Agency Alternatives Meeting

Heber Valley Corridor

ENVIRONMENTAL IMPACT STATEMENT

Alternative Concepts Agency Meeting
September 30, 2021

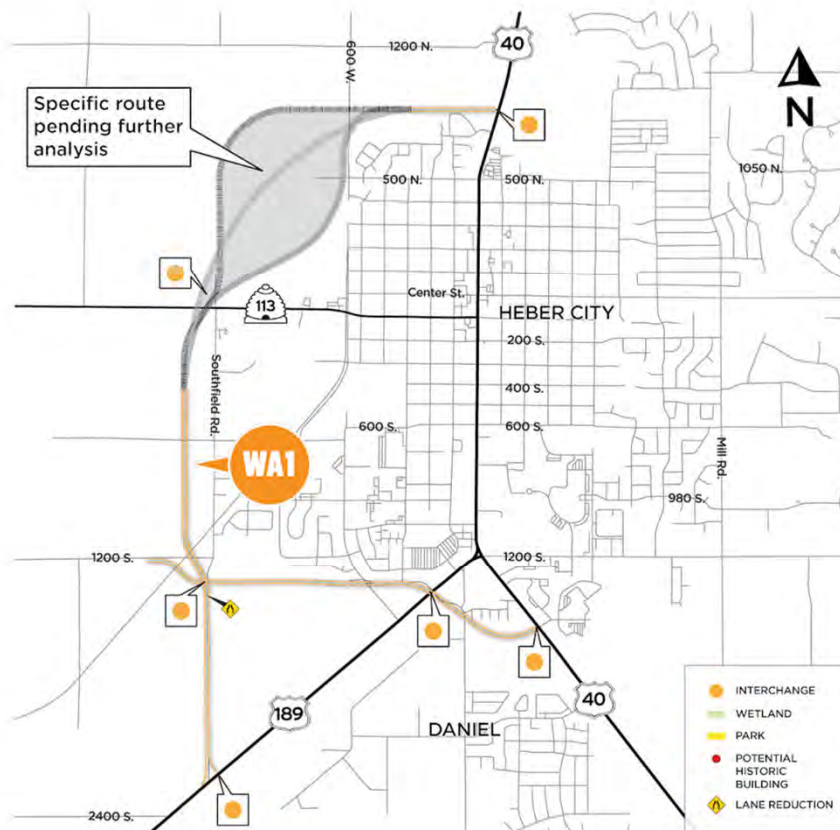
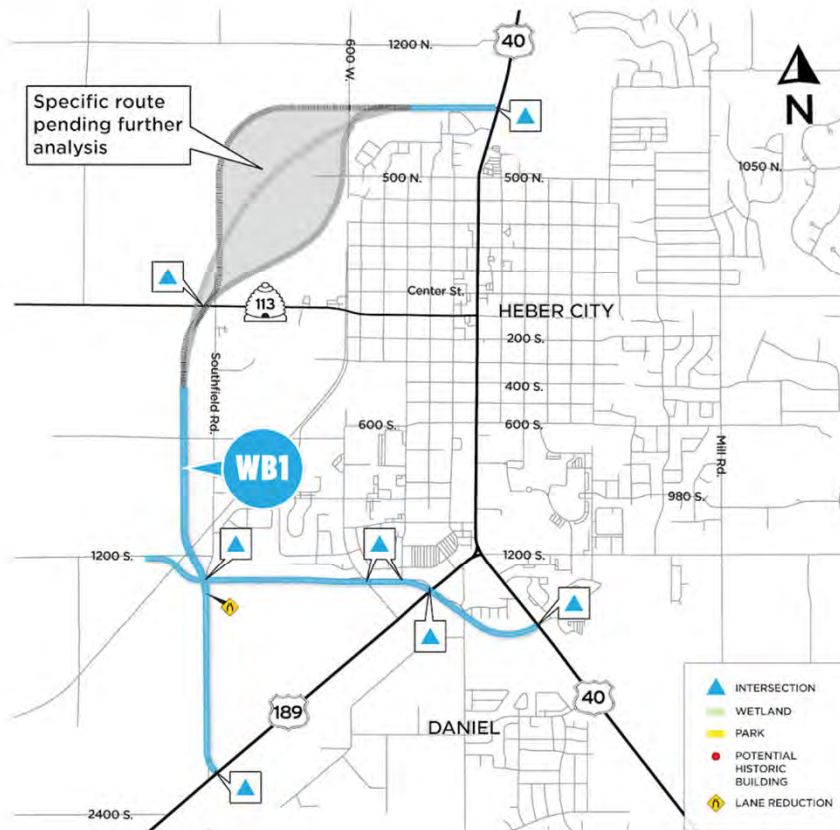
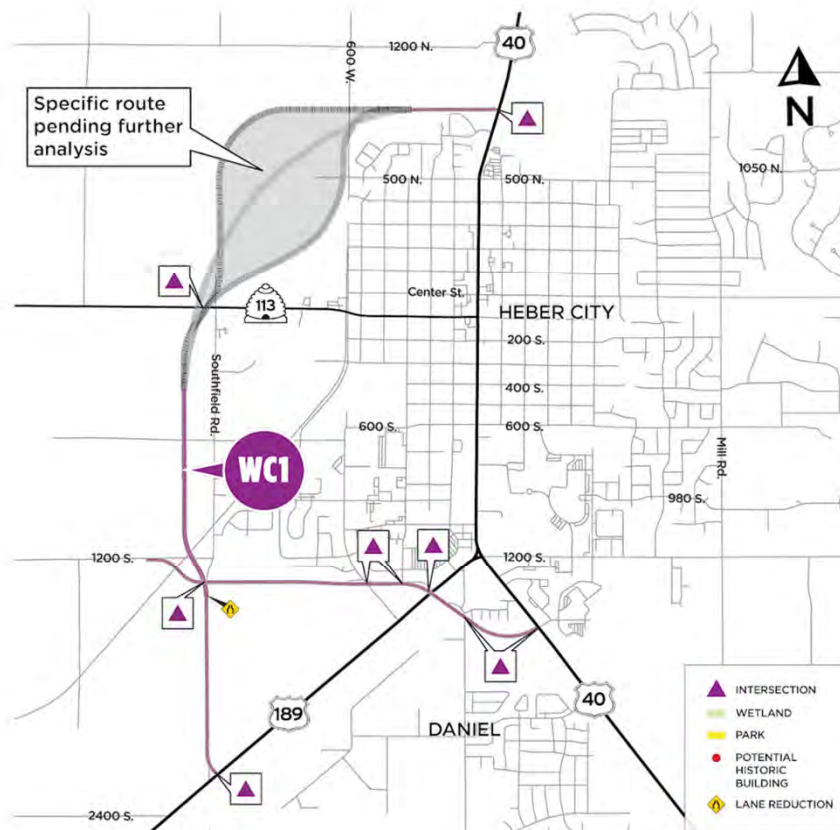
- b. The alignment in the northwest quadrant for west bypass alternative concepts WA, WB, and WC has not been determined yet. Further analysis is required (delineation and design).

Alternative WD

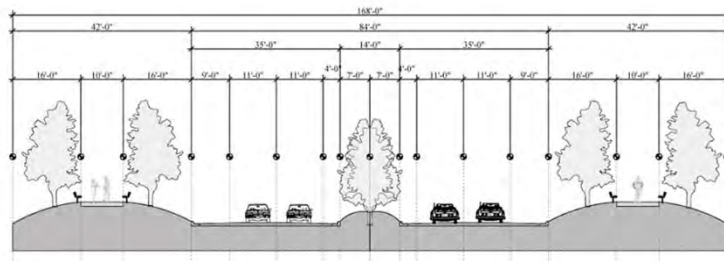
Cross section does not meet UDOT standards. This alternative was provided by a member of the public to evaluate. Any type of aesthetic or design treatments would only be considered later in the process.
